Addendum No. 1

RE: Contract # C204404

Cumberland County (U-4405A)

US-401 FROM OLD RAEFORD RD TO EAST OF NC-162 (BUNCE RD)

| DOGHOUSE MANHOLE | | FAYETTEVILLE PUBLIC WORKS COMMISSION FAYETTEVILLE, N.C. | | NO. | DATE | REVISION |

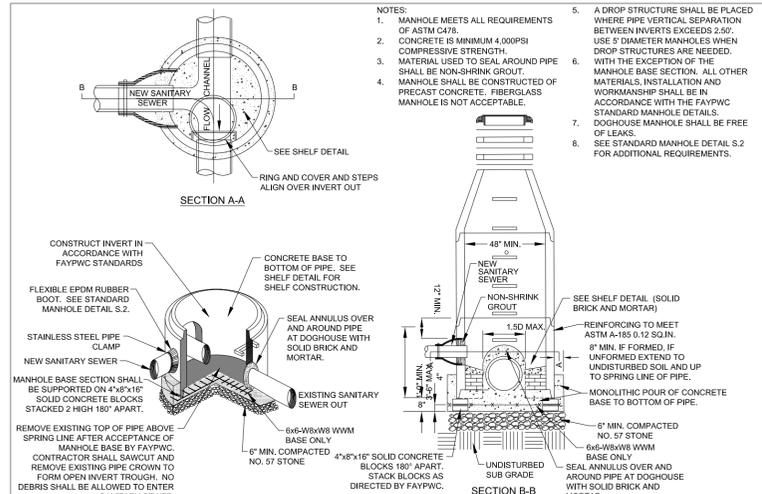
| Sheet No. | Revision |
|-----------------|---|
| UC-3I | REMOVED DETAIL S.3 SHEET 2 OF 2 |

MATCHLINE SEE SHEET UC-7
-L- STA 48+00

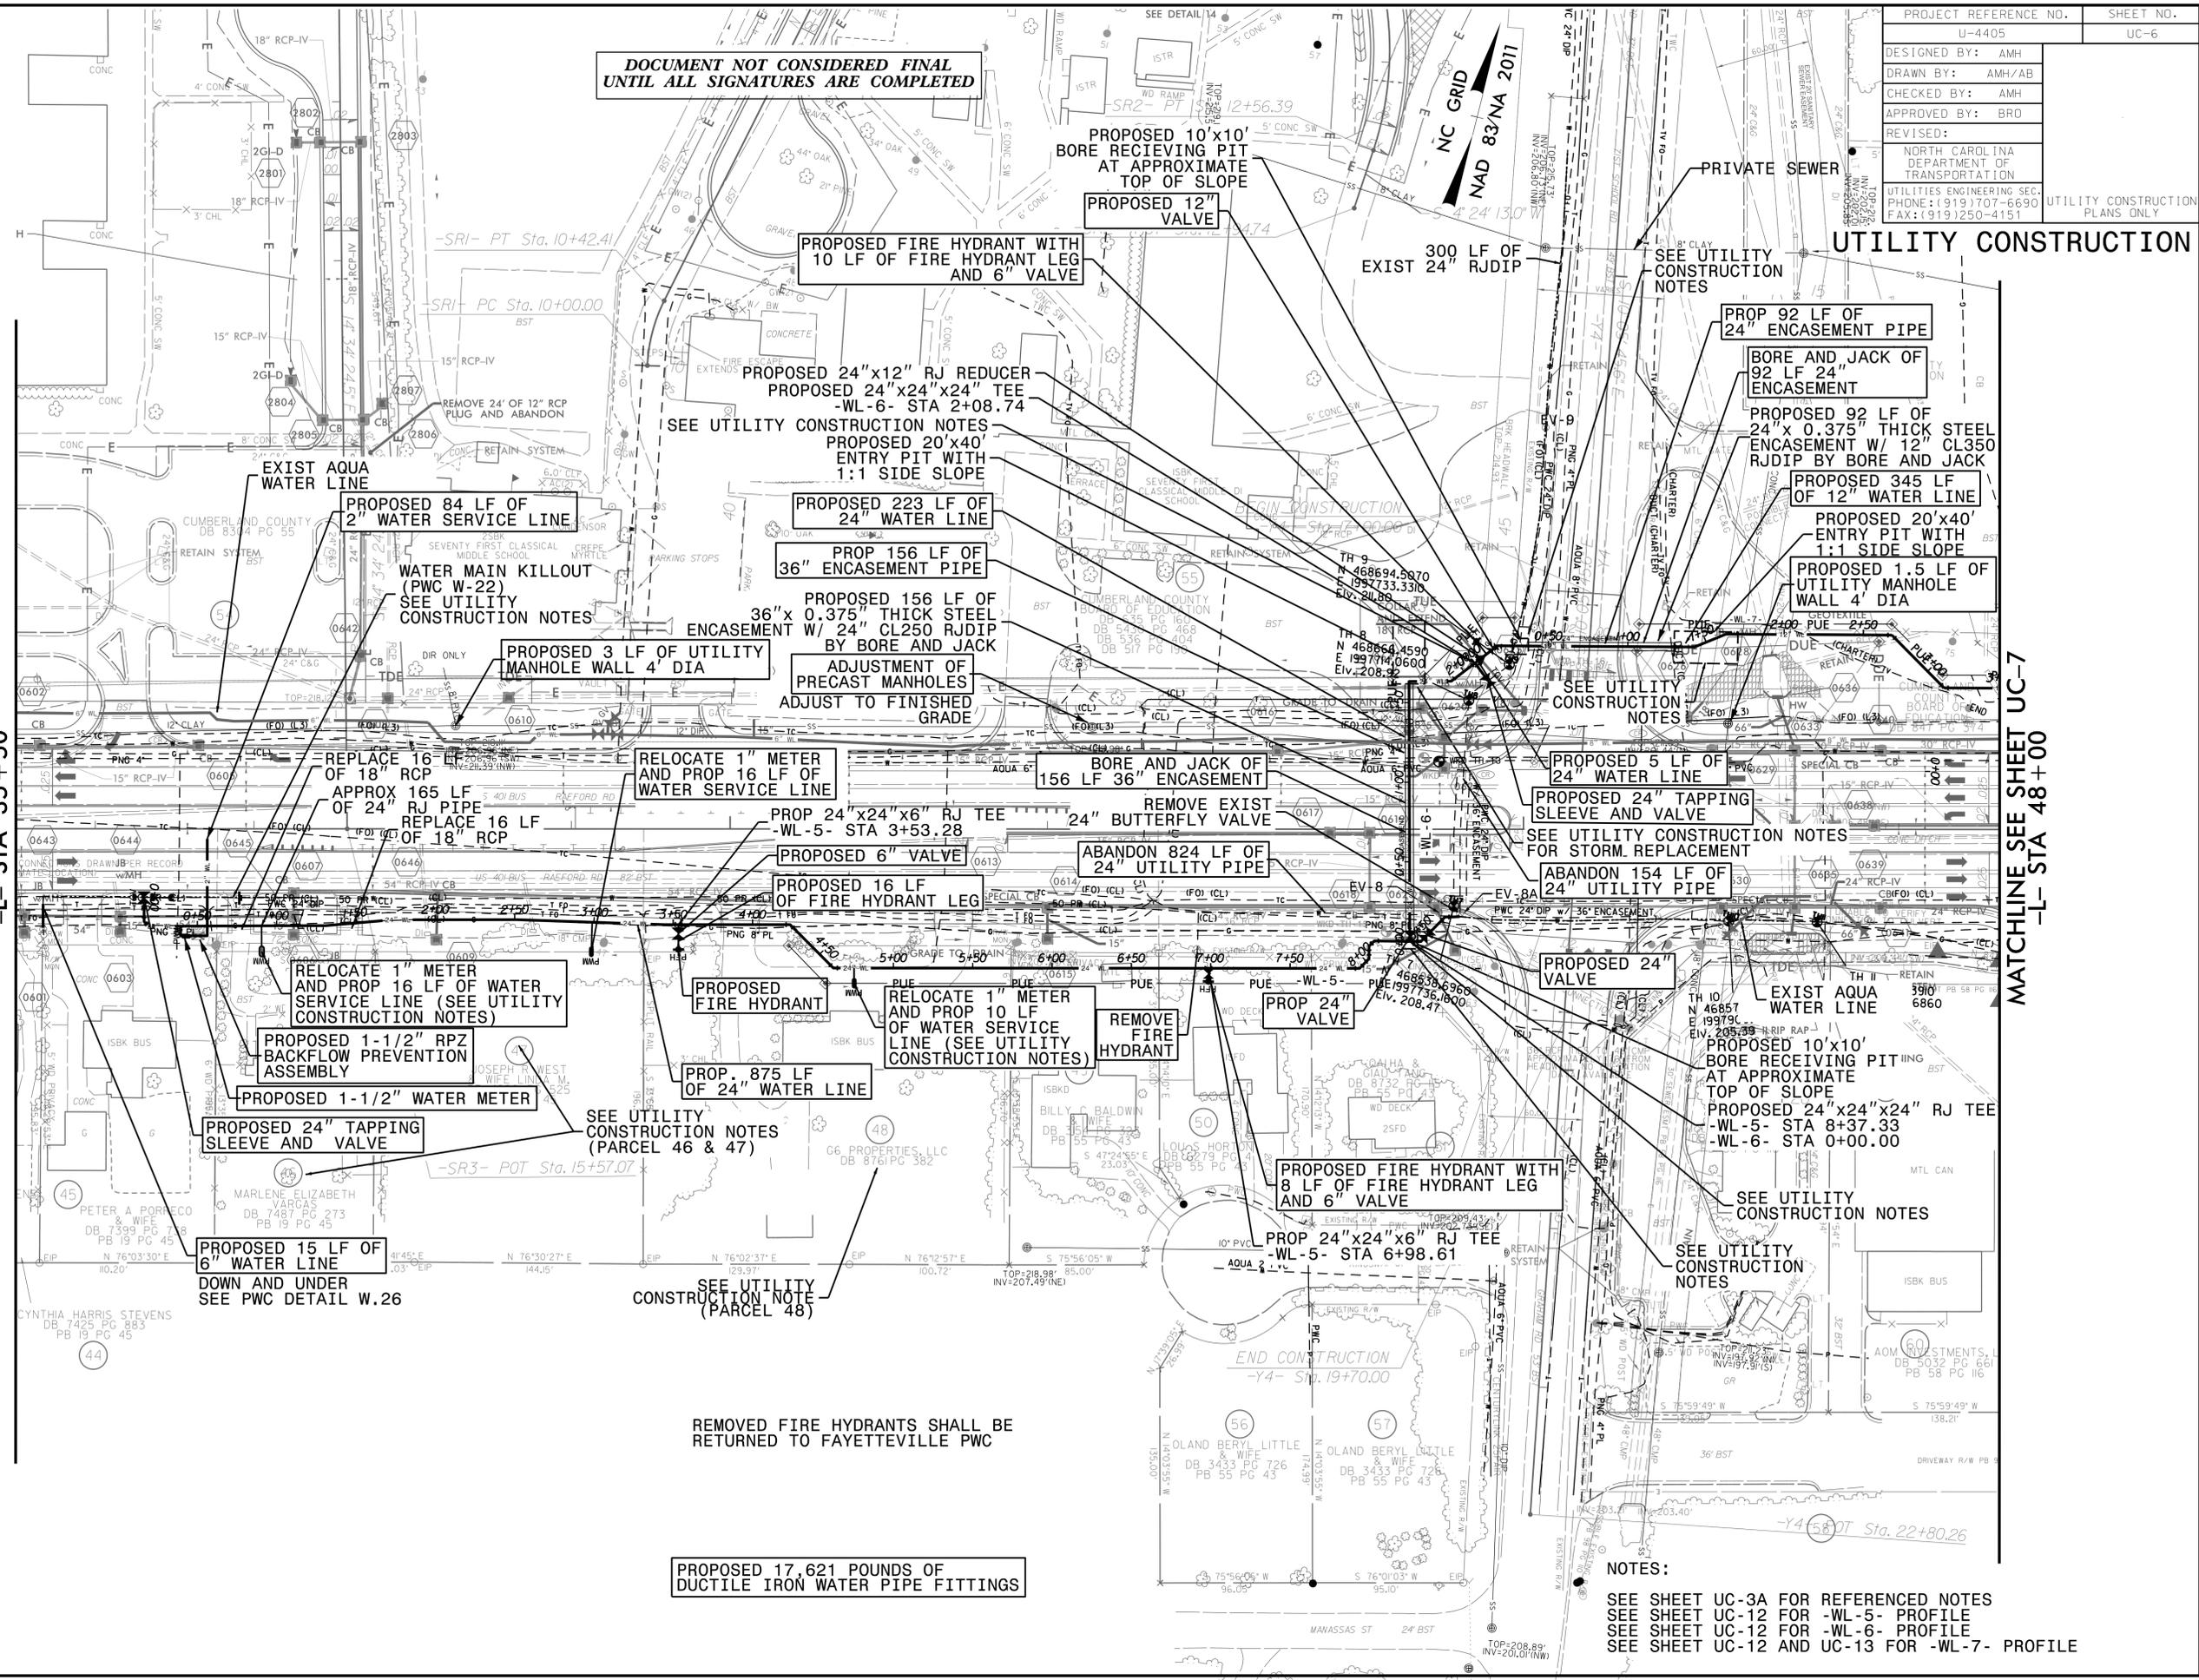
| Sheet No. | Revision |
|-----------------|---|
| UC-6 | CHANGED CL50 TO CL250/350 ROTATED METER AND RPZ AT LSTA 36+60 RT ADDED 9 LF OF WATER SERVICE LINE ADDED NOTE TO RETURN FH TO FAY PWC |

MATCHLINE SEE SHEET UC-8
-L- STA 61+50

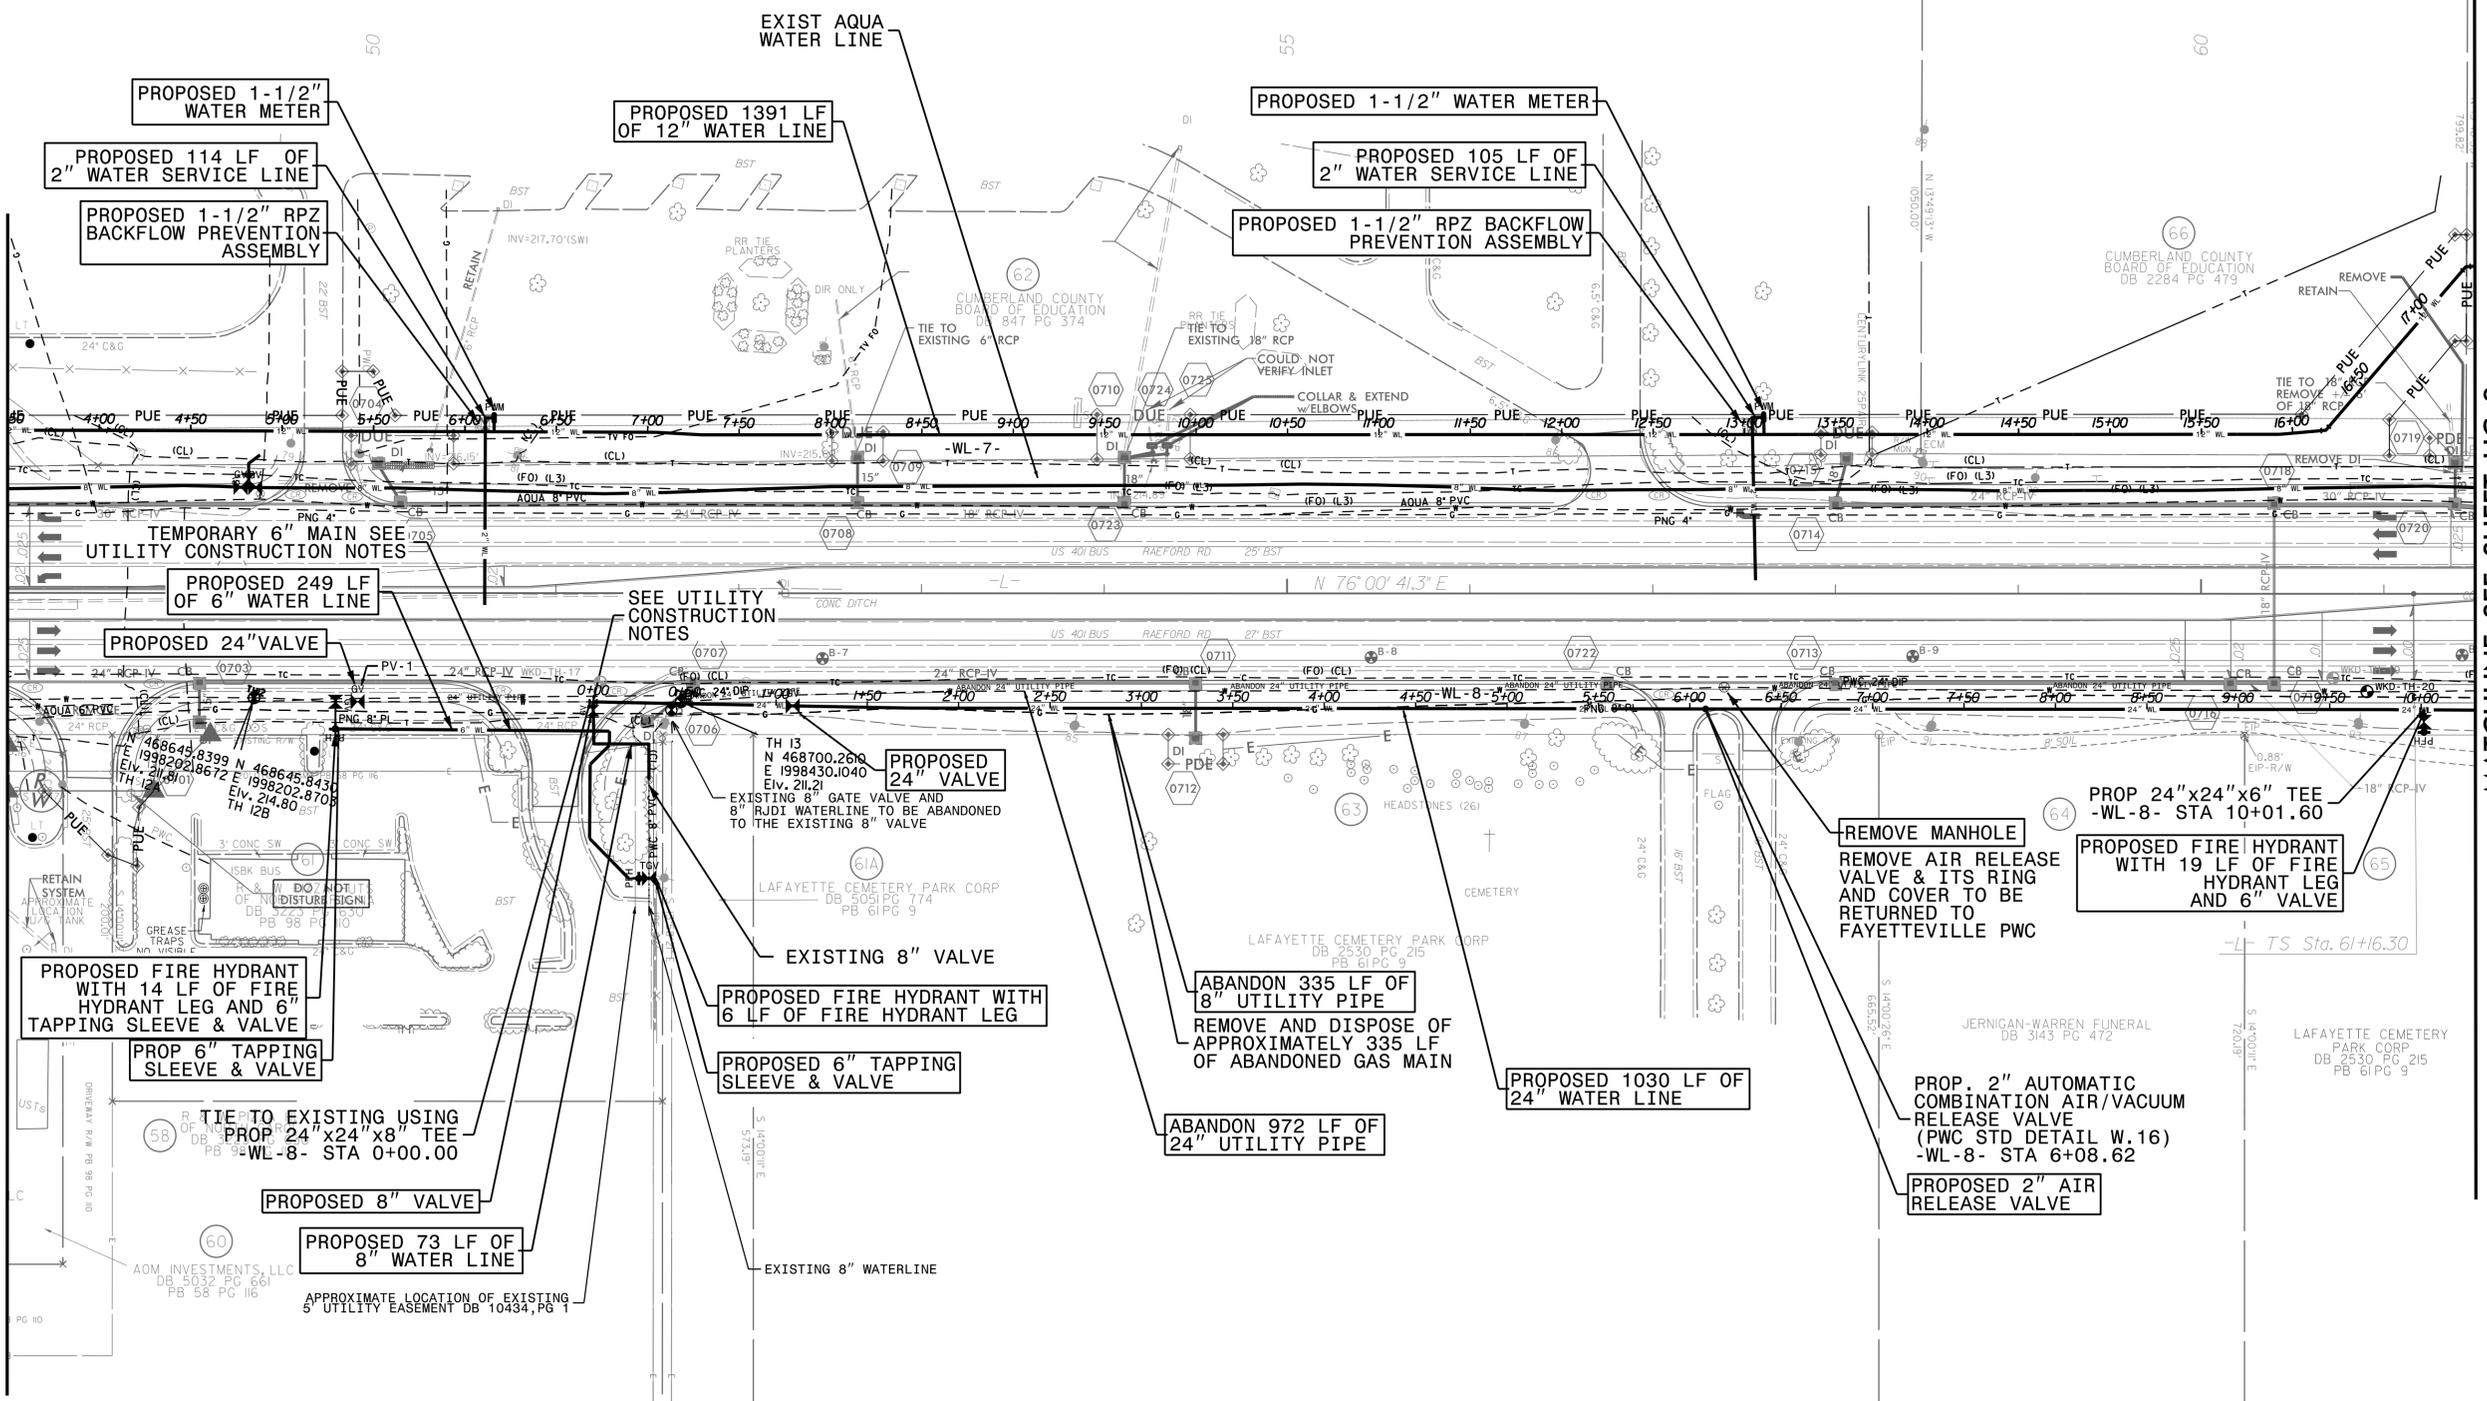
| Sheet No. | Revision |
|-----------------|---|
| UC-7 | ADDED SIZE OF PROPOSED 24" VALVE REMOVED VALVE W/ NO CALLOUT LSTA 51+40 RT REMOVED ERRANT FHA AT LSTA 56+85 RT LSTA 57+25 RT, ADDED TEXT UNDERNEATH REMOVE MH CALLOUT TO RETURN ARV TO FAY PWC |

MATCHLINE SEE SHEET UC-10
-L- STA 88+00

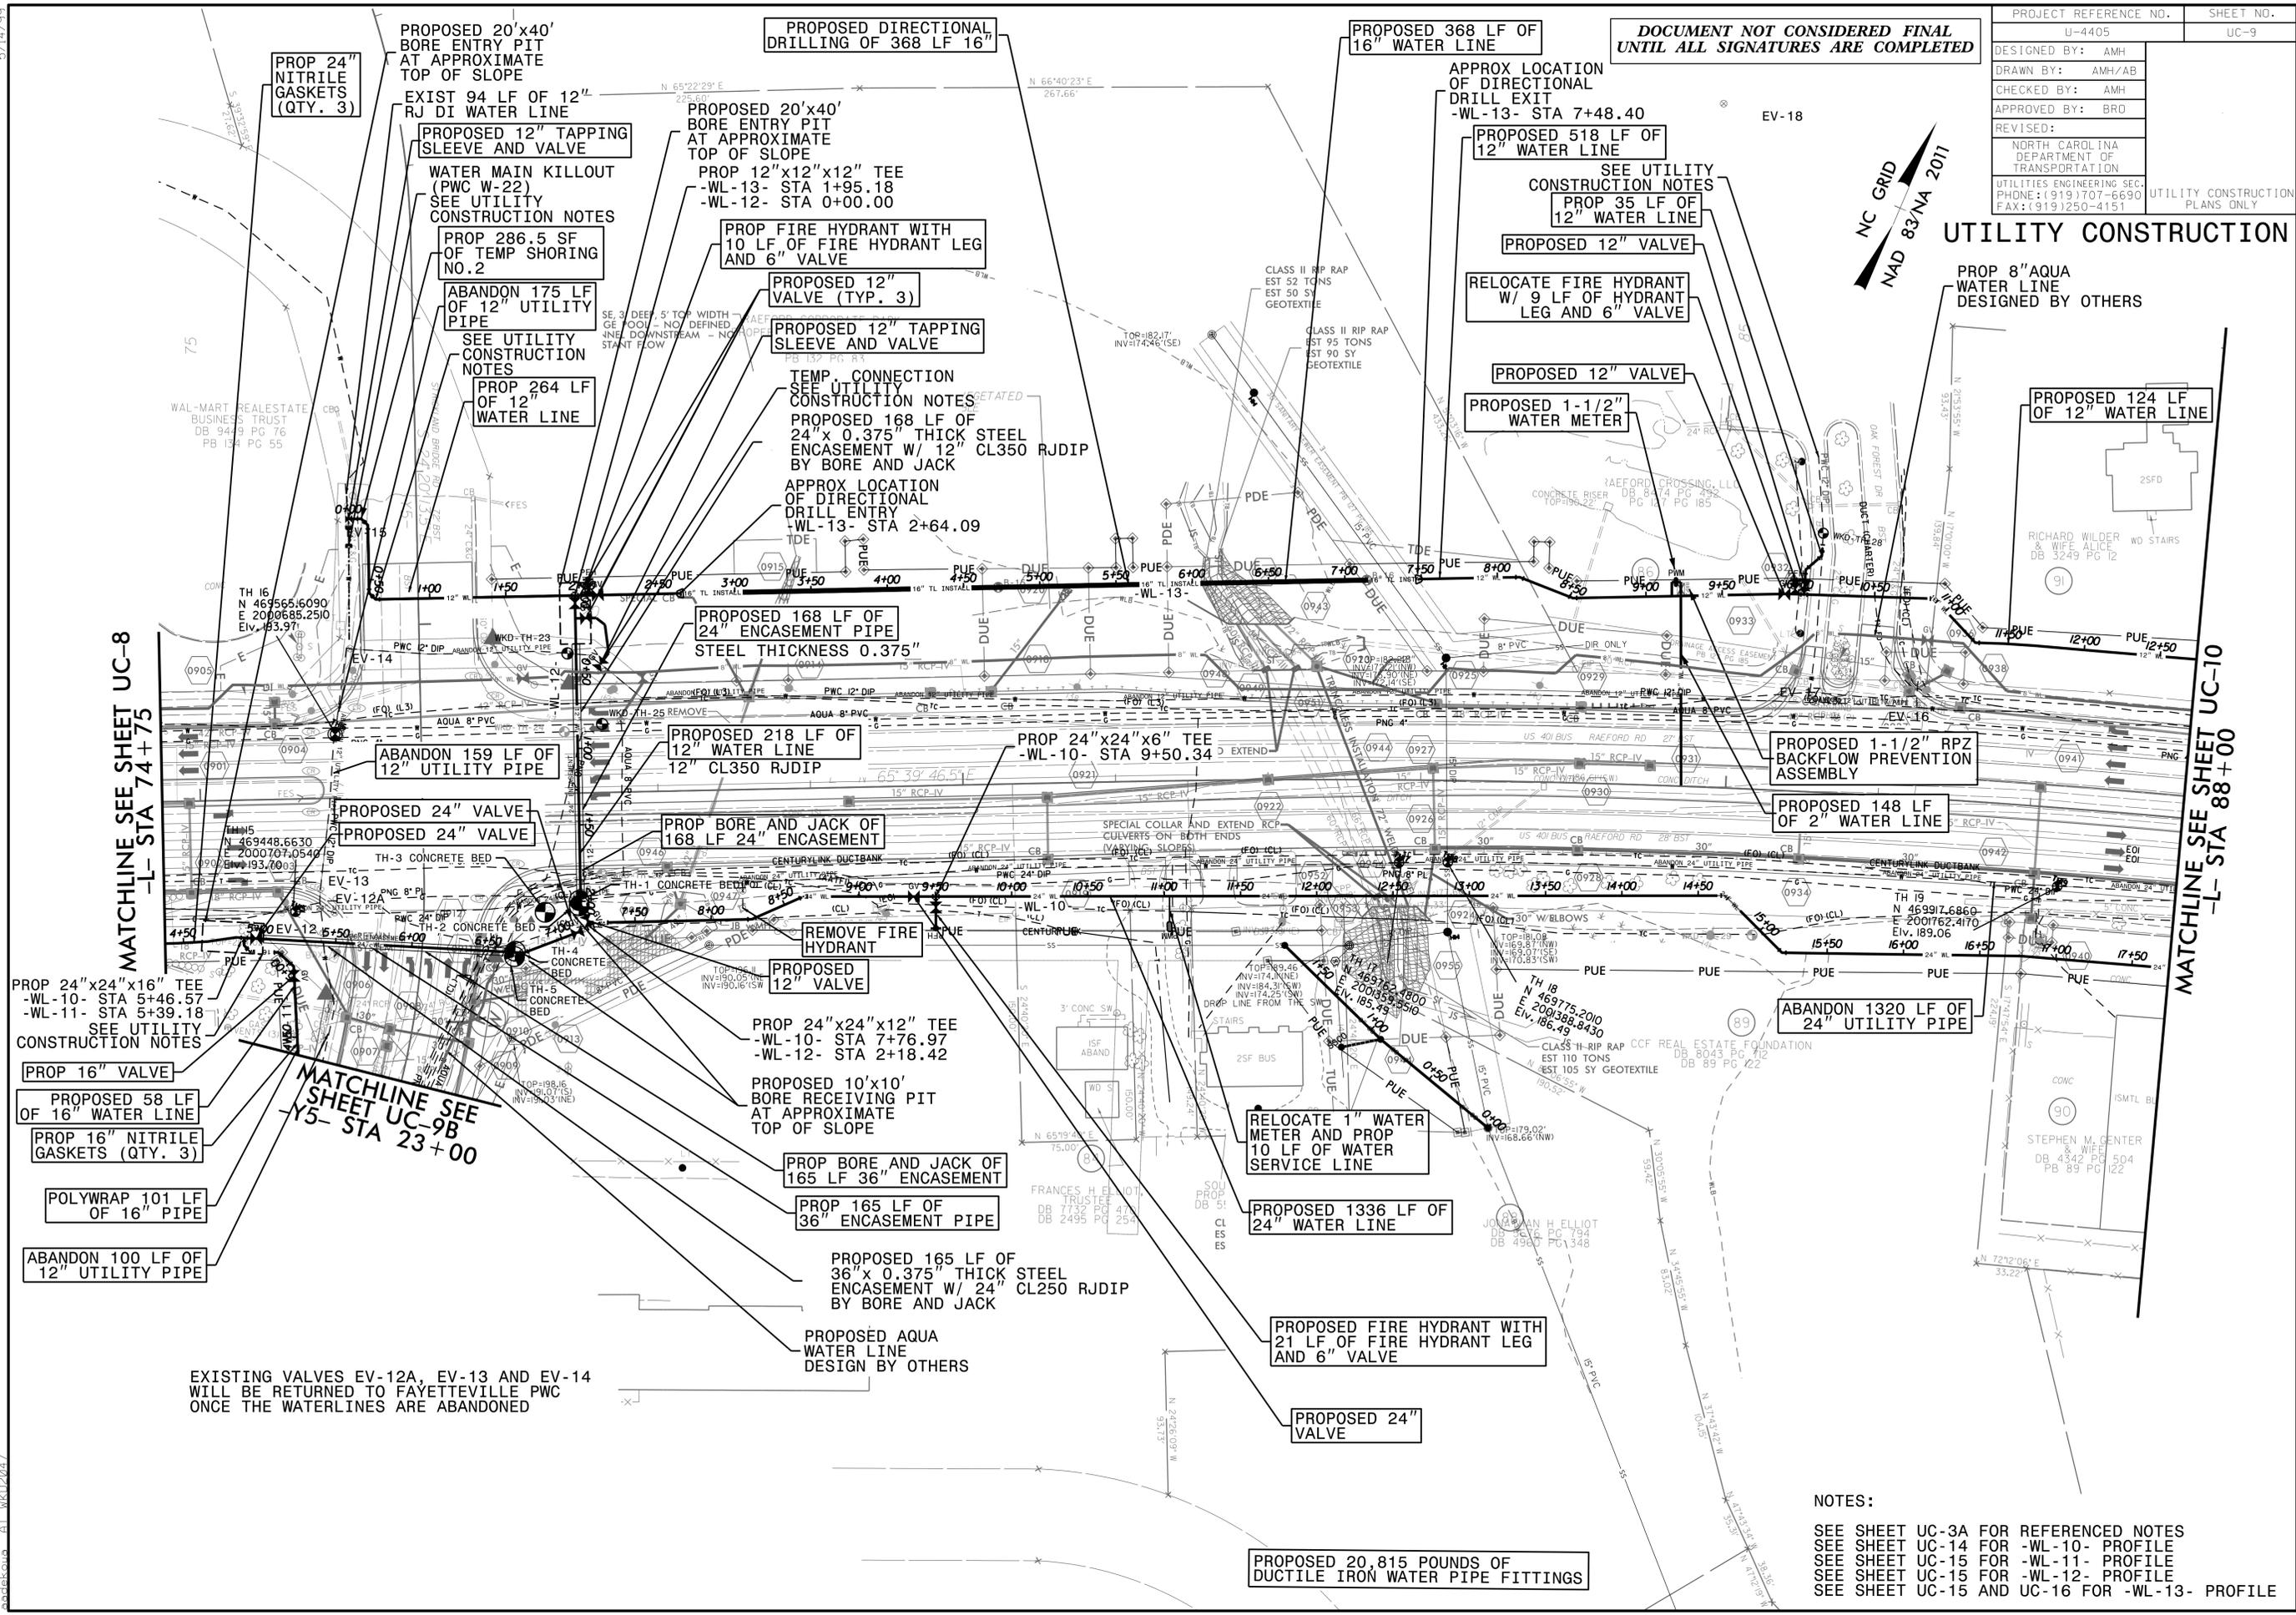
| Sheet No. | Revision |
|-----------------|---|
| UC-9 | ADDED CALLOUT FOR BORE AND JACK PIPE MATERIAL CHANGED CL50 TO CL250/CL350 ADDED NOTE FOR EXISTING VALVES TO BE RETURNED TO FAY PWC |
